Subject: AP1000 Response to Request for Additional Information (SRP 6)

# AP1000 TECHNICAL REPORT REVIEW

RAI Response Number: RAI-SRP6.2.2-SRSB-01  
Revision: 2

RAI Response Number: RAI-SRP6.2.2-SRSB-02  
Revision: 2

**Table 2 from NUREG/CR-6877**

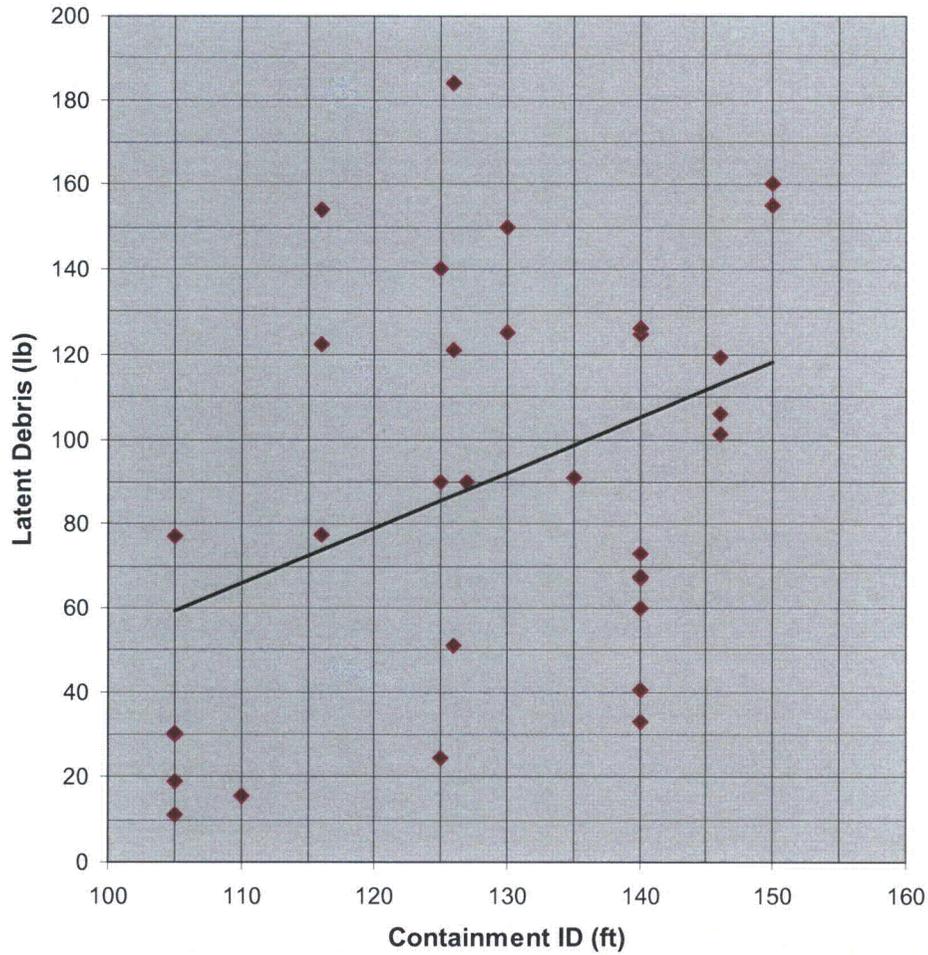
- a. Provide the references or sources of the operating plant walkdowns and debris samples. Confirm that the percentages of various debris types are based on total volume, as reported, and not total mass (NRC SE of NEI 04-07 recommends that fiber be 15% of total mass).
- b. Explain why these references and data are representative of the AP1000.
- c. Describe whether there could be other types of latent materials in the AP1000 that are different from the operating plants.
- d. Explain how actual as-designed and operated AP1000 will be verified to be consistent with this data both prior to start-up and during the life of the plant? Propose appropriate surveillance testing and/or programmatic controls that will be necessary to ensure the actual plant is operated consistent with the analysis assumptions.

Using the data provided in Table 2 of NUREG/CR-6877, it is seen that 3 of the 4 plants evaluated in the manner described in the NEI 04-07 SER have less than 7.5 percent fiber in their latent debris totals. The data in table 2 of NUREG/CR-6877 illustrates that the average fibrous debris load of the four plants is 7 % and two of the four plants had less than 4 % fiber. Of 28 plants sampled for the Generic Letter 2004-02, 'Supplemental Responses and Close-Out', responses, only one has proposed a fiber content less than 15%. This plant performed a debris characterization per the NEI 04-07 SER and, concluded that an appropriate latent fiber fraction should be 2.7%. Observations from other plant walkdowns included statements such as 'dust with no fiber', 'visual inspection showed very little fiber content', and 'visual [examination of the debris] showed very little fiber', further indicating that the assumption of 15% latent fiber is extremely conservative.

NOTE: \* Los Alamos removed larger / heavier particles from the plant samples in their work for NUREG/CR-6877 because they thought they would not transport. This debris ("Other") is shown added back in in the lower set of values. Separating out such debris is not anticipated to be done by utilities; it also does not reduce the amount of fibers, just the percentage.
